Item No.: 24A-TTC-03  
Technical Correction

## NCUTCD PROPOSAL FOR CHANGES TO THE MANUAL ON UNIFORM TRAFFIC CONTROL DEVICES

**COMMITTEE / TASK FORCE:** Temporary Traffic Control TC  
**ITEM NUMBER:** 24A-TTC-03  
**TOPIC:** Technical Correction –Remove North Arrows from Part 6 Figures  
**ORIGIN OF REQUEST:** TTC Technical Committee  
**AFFECTED SECTIONS OF MUTCD:**

**Figure 6P-1. Work Beyond the Shoulder (TA-1)**

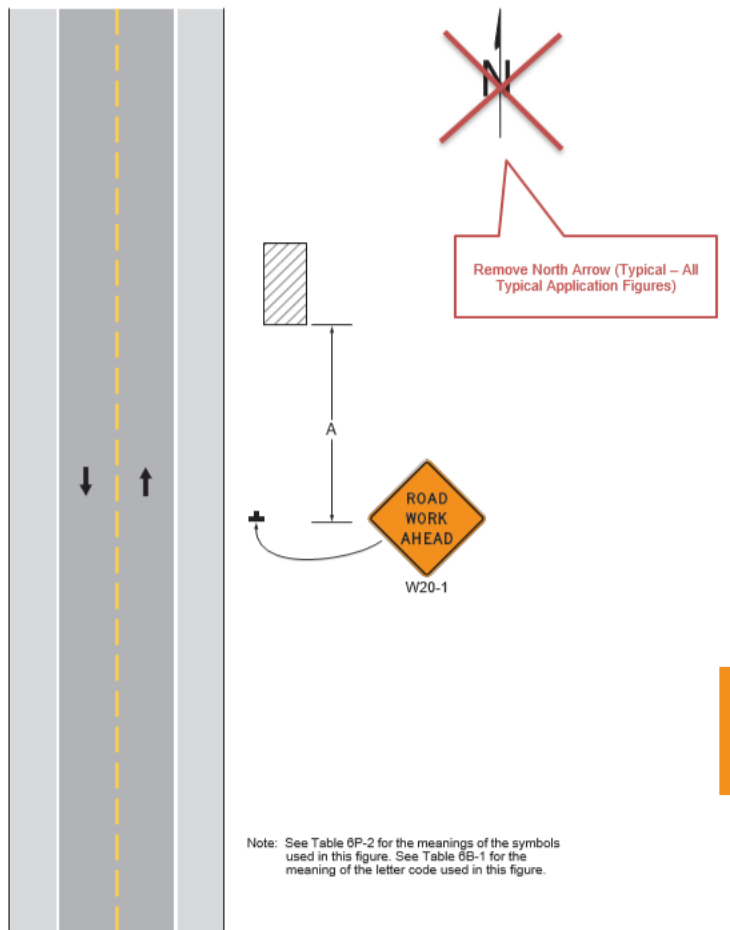
26 A north arrow has been added to Figures 6B-1, 6B-2, and 6B-3 in Chapter 6B; Figures 6L-1 and  
27 6L-in Chapter 6L; Figure 6N-1 in Chapter 6N; and Figures 6P-1 (Typical Application 1) through  
28 6P-54 (Typical Application 54) in Chapter 6P, without public review. The affected typical  
29 application applies to all roadways not just northbound travel on roadways with a north-south  
30 configuration. The 11th Edition introduced North Arrows on all of the Typical Application figures  
31 that are contained in Chapter 6P, Typical Application, however this was not included as part of  
32 the NPA and is new content.

33  
34 MUTCD Typical Application (TA) figures are meant to represent common Temporary Traffic  
35 Control (TTC) scenarios that may be applied along any roadway regardless of traffic or geo-  
36 magnetically direction (i.e. north, east, south and west). North Arrows are typically placed along  
37 plan sets that have geographical references such as Latitude and Longitude. North Arrows on a  
38 TA may confuse the end users in the field allowing them to assume that they may only be able  
39 to use any of the MUTCD TAs if they are working along a roadway in the northbound direction  
40 leaving them to believe that they cannot use the TA for any other directional roadway.  
41

[The following is an example of the North Arrow removal recommendation. The recommendation applies to Figures 6B-1 through 6B-3, 6L-1 and 6L-2, 6N-1, and 6P-1 through 6P-54.]
